REPORT TO PLANNING & ZONING COMMISSION

CITY OF MARYLAND HEIGHTS

APPLICATION NUMBER	PDP22-0013
APPLICATION (PROJECT) NAME	ALDI – DORSETT SQUARE
APPLICANT NAME	ALDI 475 Pearl Drive, O'Fallon, MO 63363
PROPERTY OWNER NAME	Berg Cahokia, LLC 1325 Queens Court, Saint Peters, MO 63376
APPLICANT'S REQUEST	Minor modification to Planned District Ordinance 2011-3490 (as amended) to reduce the required number of parking spaces
SITE LOCATION	Southwest quadrant of Dorsett Road and McKelvey Road
STREET ADDRESS	12626 Dorsett Road
PARCEL/LOCATOR NUMBER	140511167 and 140440580
EXISTING ZONING DISTRICT	"PDC" Planned District—Commercial
TOTAL SITE AREA	7.988 acres
MEETING DATE	December 13, 2022
REPORT DATE	December 6, 2022
CASE MANAGER	Michael Zeek, AICP
RECOMMENDATION	APPROVAL

EXHIBIT B: SITE PLAN

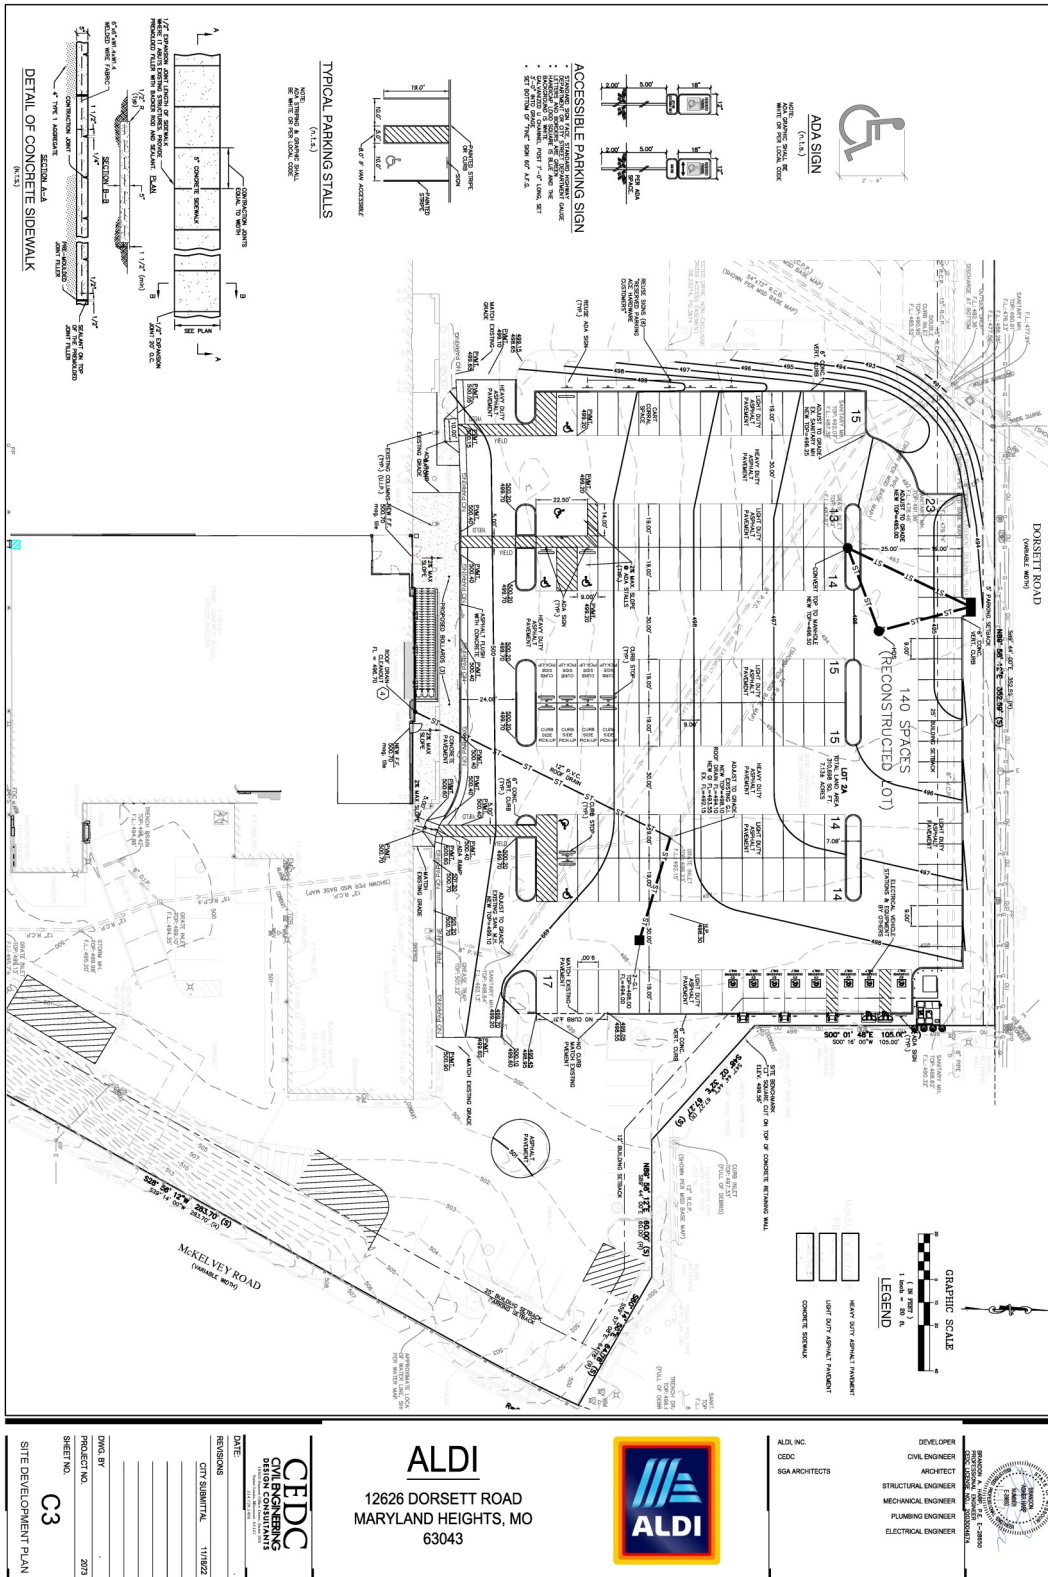
The proposed land use, a grocery store, is not at issue because grocery stores are a permitted use at this location. Instead, the subject of this request is a reduction in parking from the 420 parking spaces required by the ordinance governing this Planned District to 375 parking spaces. The basis of the requirement that 420 parking spaces be provided was the site plan submitted for the McDonald's reconstruction in 2007. That plan provided 423 spaces, so the ordinance was written to require that number of parking spaces. Interestingly, CBB's traffic study included with that request found: "The heaviest parking demands occupied no more than 60% of the existing parking supply." That number was subsequently reduced to 420 parking spaces by Ordinance 2012-3643.

Dorsett square is 79,180 in gross leasable area. Parked at a formula of 4.5 spaces per 1,000 square feet, a total of 324 parking spaces are required. Subtracting the 45 spaces provided on the *McDonald's* parcel, 330 are proposed, satisfying the required number of parking spaces despite the reduction.

EXHIBIT C: LANDSCAPING PLAN

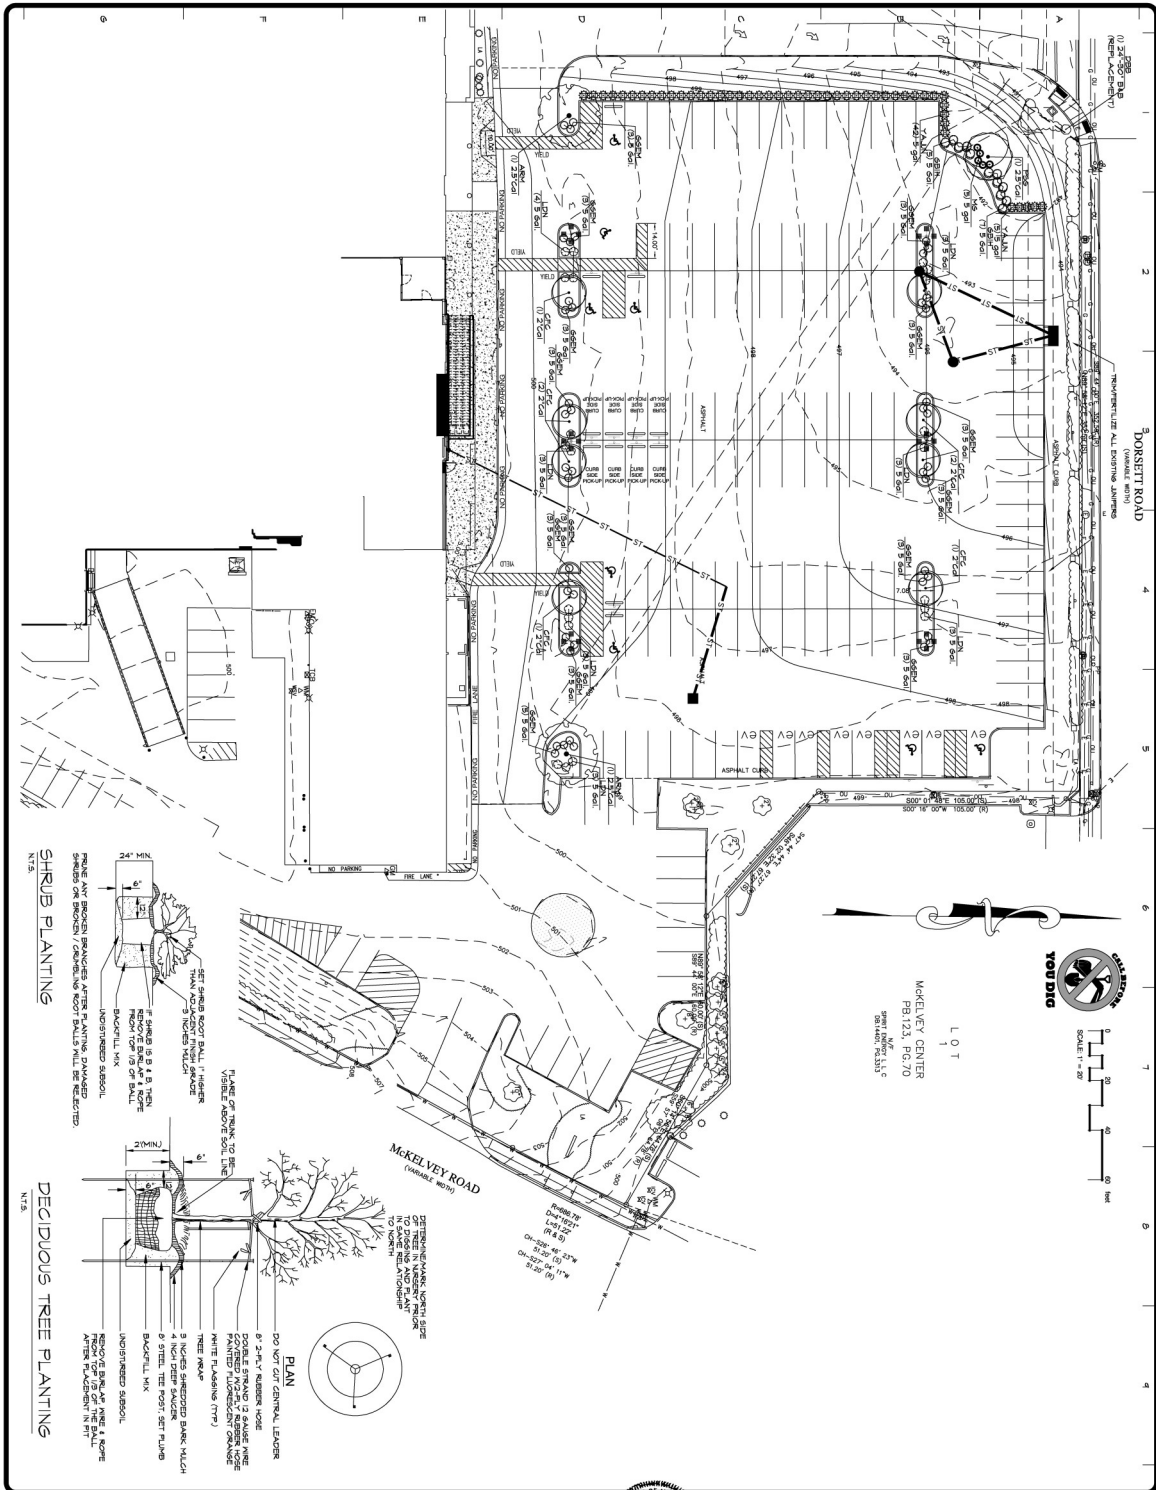
The landscaping plan shows the replacement of the plant material being removed by the parking project. In all, 11 trees and 126 shrubs will be planted. The landscaping along Dorsett Road and the decorative masonry bollards will be maintained. Staff is of the opinion that the proposed landscaping plan is acceptable.

EXHIBIT D: LIGHTING PLAN

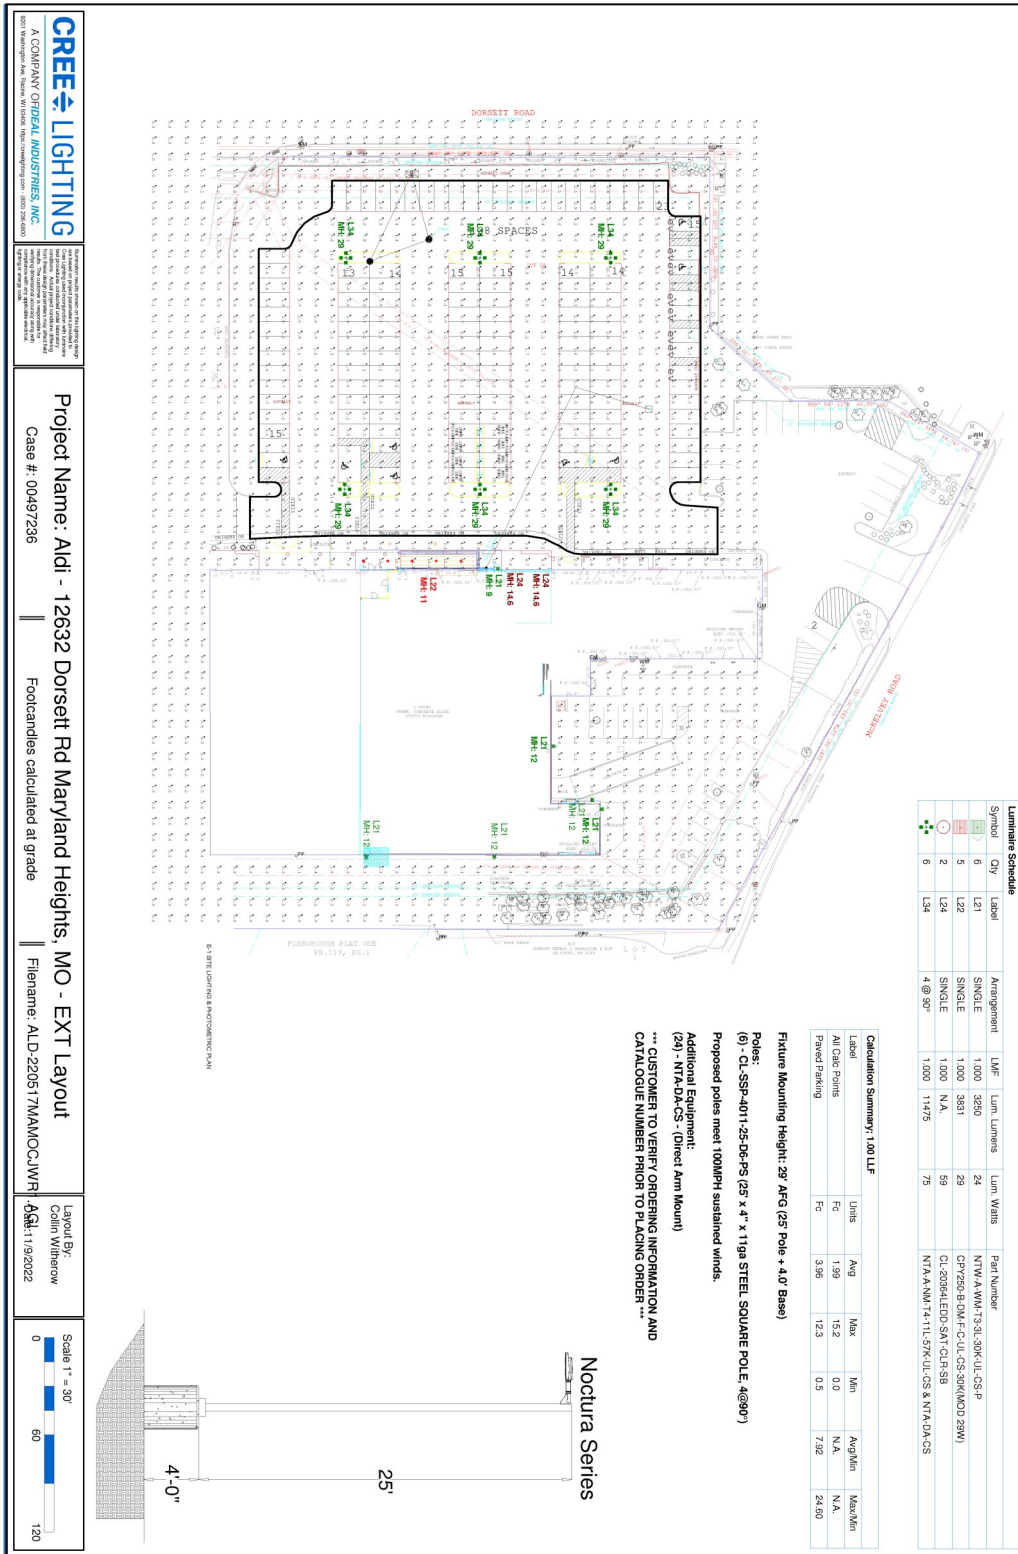
The proposed lighting standards shown on the plan are 29 feet in height. They satisfy the Lighting Design Standards of the Zoning Code, which limit the height to 30 feet, but do not satisfy the requirements of the current Dorsett Square ordinance. Additionally, the parking area would have an average of almost 4 footcandles under the proposed plan while the existing parking area has an average of closer to 2 footcandles. The draft ordinance prepared by staff simply requires conformance with Article 18, Lighting Design Standards, of the Zoning Code. The proposed lighting will be reviewed in greater depth during the site improvement plan process.

2. The City Planner finds that the request is consistent with the parking regulations of the Zoning Code. Consistency with other standards, such as the Lighting Design Standards, will be addressed during the site improvement plan review process.
